RE: 845 Juan Tabo Blvd NE
Grading & Drainage Plan
Engineer's Stamp Date: 04/29/24
Hydrology File: K21D019

Based upon the information provided in your submittal received 04/30/2024, the Grading & Drainage Plans **are not** approved for Building Permit, Grading Permit and SO-19 Permit. The following comments need to be addressed for approval of the above referenced project:

845 JUAN TABO BLVD., NE
GRADING AND DRAINAGE PLAN

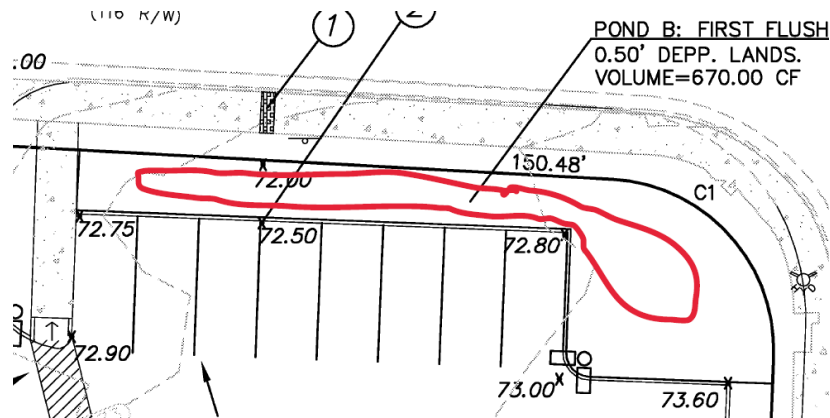
2. Please show the existing bus stop on Lomas. Also, please contact Transit, they may want this to be upgraded to be similar to the other on Juan Tabo.

3. Please show the top of the Stormwater Quality Pond at the Northeast corner of the property. Cannot tell if there is enough volume as indicated. Also, it appears that the sidewalk culvert is at the location of the bus stop. This may have to be shifted over to the west.

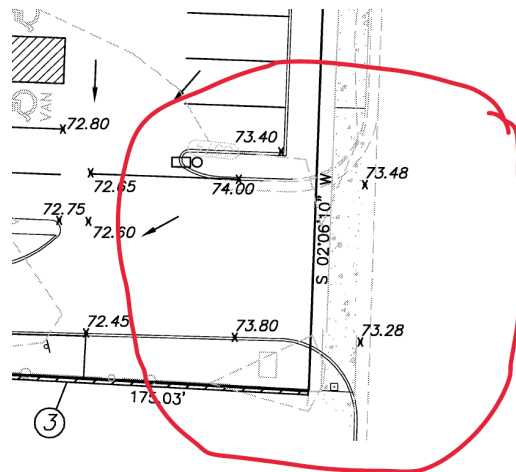
4. The proposed entrance on Juan Tabo needs some attention. First the existing drive is a driveway and does not have a proper curb radius per CoA paving detail 2426. Second, the other radius has to become tangent before the property line. This cannot encumber the adjacent property owner. Please fix. And third, please show the existing power pole that is near the property corner.

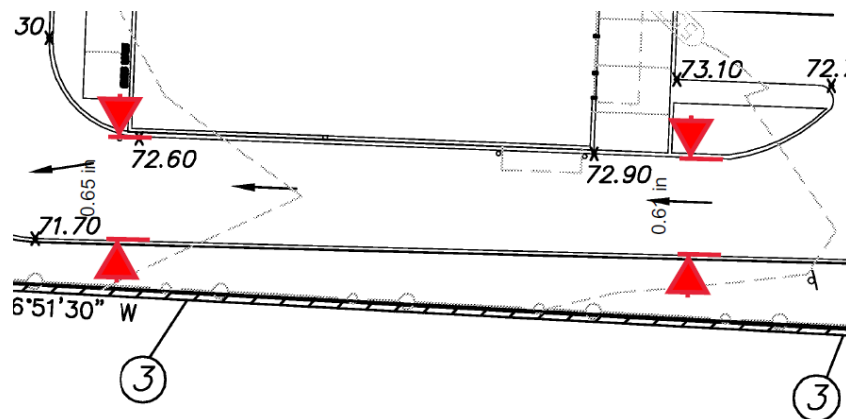
6. Is there a reason why the drive-thru lane is not the same width? It is about 13 feet wide at the west corner of the building and about 12.2 feet wide at the eastern corner.

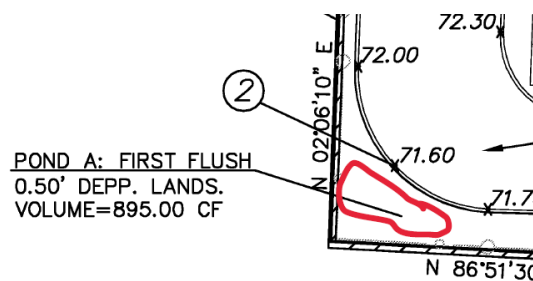
7. Please show the top of the Stormwater Quality Pond at the Northeast corner of the property. Cannot tell if there is enough volume as indicated.

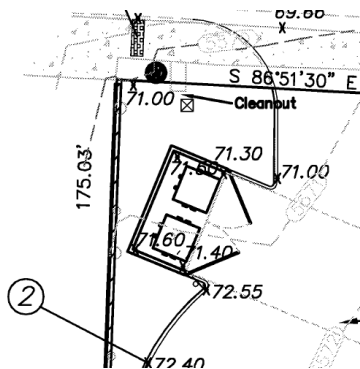
8. Not sure how the Stormwater Quality Pond A is to drain to Lomas. The space that is there is only 1.5 feet wide which is not wide enough to build a swale 0.5 feet deep. This will need to be a minimum of 3 feet wide.
